No. 88-9

Power Trim Control P/N 55642A13 Assembled Wrong

Figure 1.

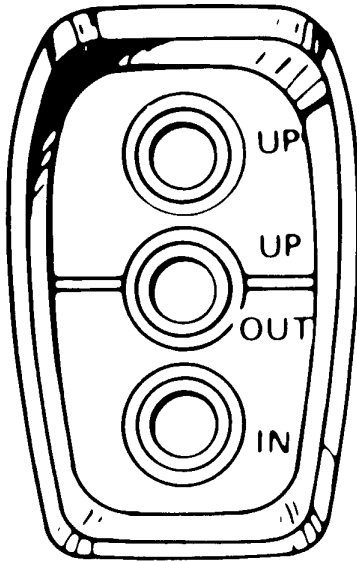
There may be some three button Power Trim Controls P/N 55642A13 manufactured with the panel face mounted wrong. Symptoms of the incorrect panels are; push the "UP" button, drive unit will go down "IN", push the down "IN" button, drive unit will go "UP". (Figure 1) To correct this problem remove control panel from dash (if installed in boat), remove four retainer screws, turn panel face 180° and re-install retainer and screws. (Figure 2)
